FOR THE DEVELOPMENT PERMIT BOARD
JANUARY 12, 2015

1600 HARWOOD STREET (COMPLETE APPLICATION)
DE418164 - ZONE CD-1

EXECUTIVE SUMMARY

SHEET NO.: **DP 7.100**

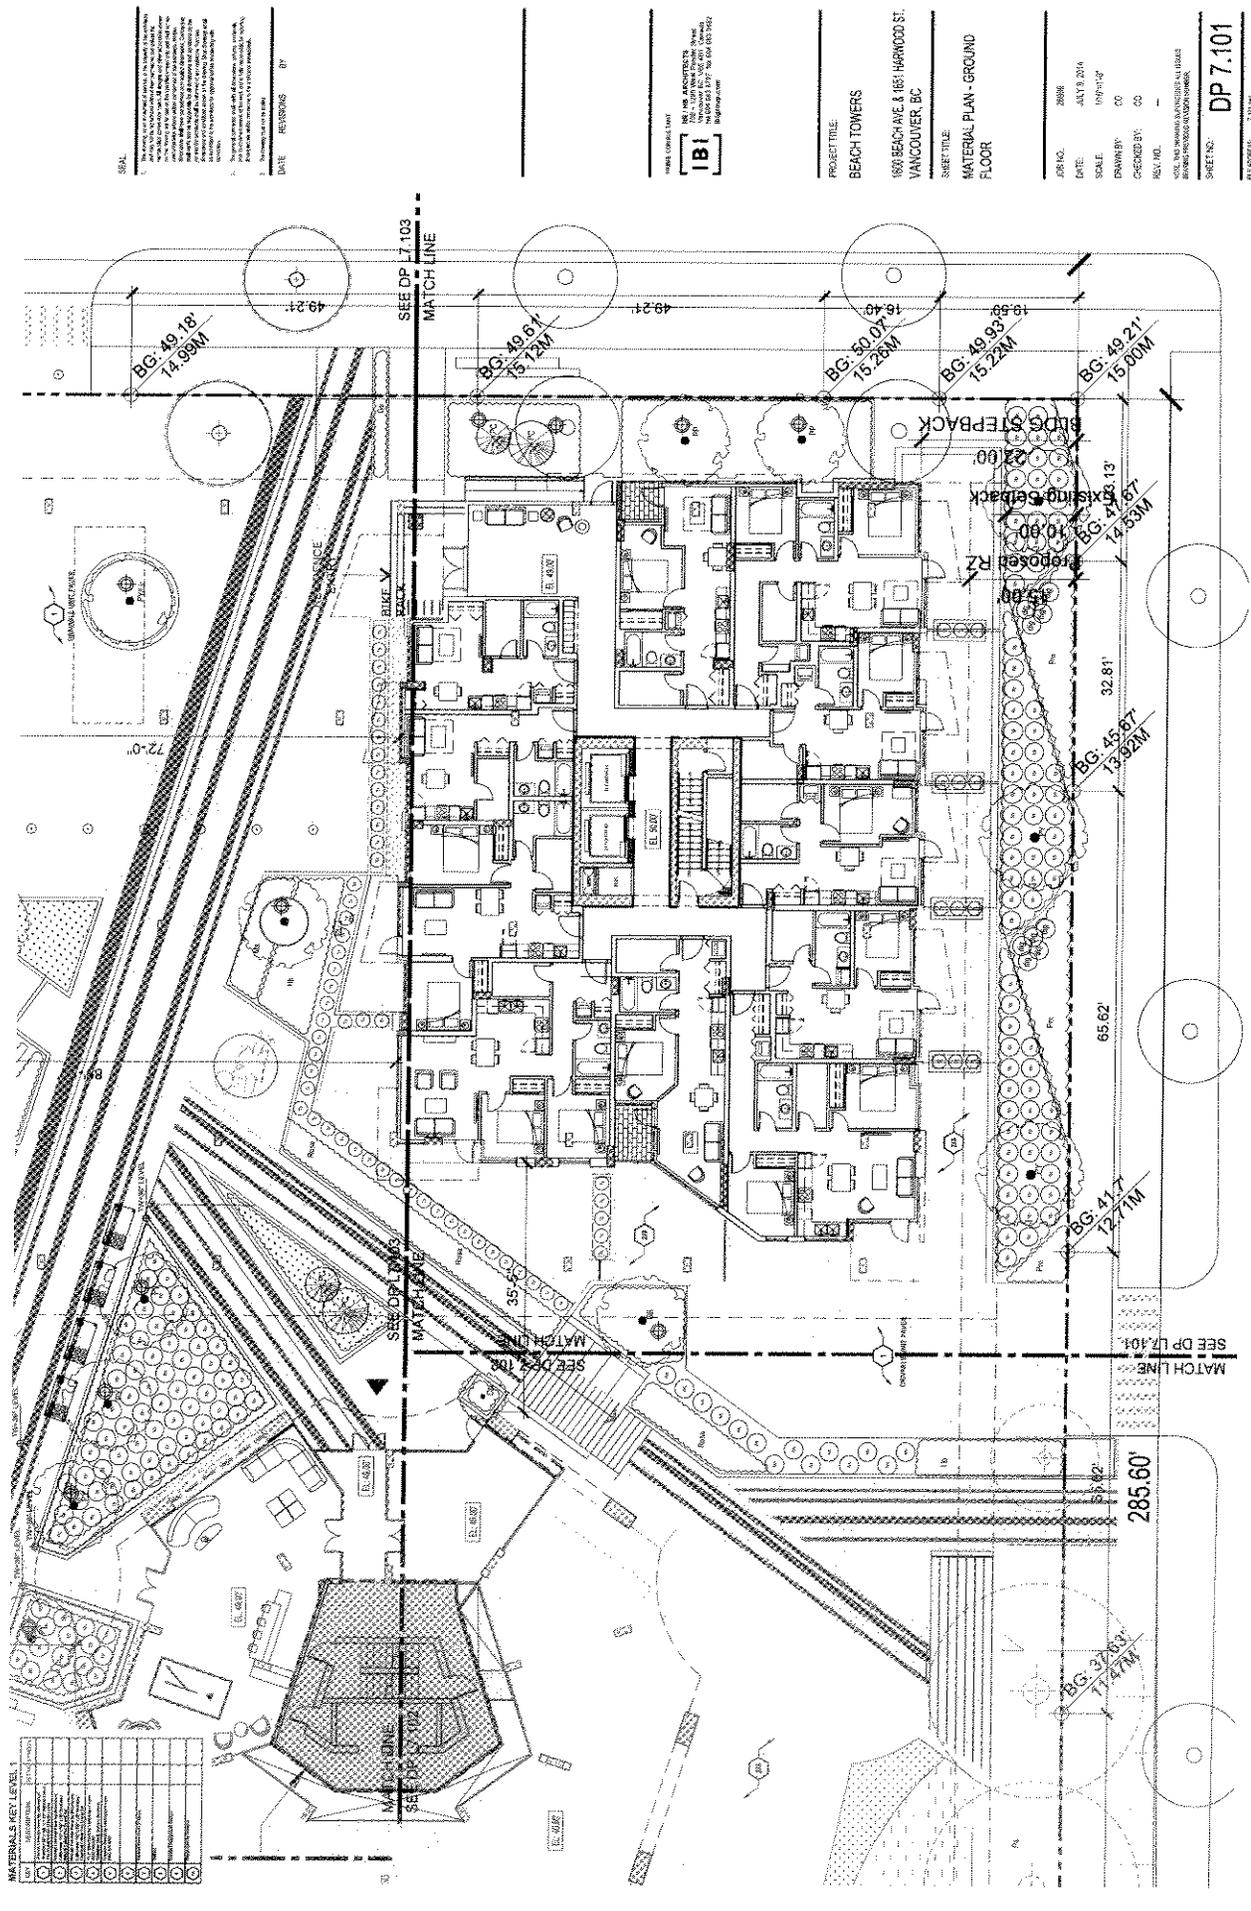
- e) provision of more standard information and labels (sheet DP 7.100), such as street names, section indicators, north arrows, sheet labels;
- f) provision of large scale, detailed plans for the agriculture amenity outdoor area and play areas (note: these areas should be highly detailed and programmed);
- g) illustration of spot elevations to all outdoor areas (including top/ bottom walls), including offsite context spot elevations in proximity (such as the public sidewalks, inner boulevards and lanes, for example);
- h) full detailing of the public realm with regard to existing and proposed materials, trees, tree protection barriers, planting, walkways and related infrastructure (for example, light poles, fire hydrant);
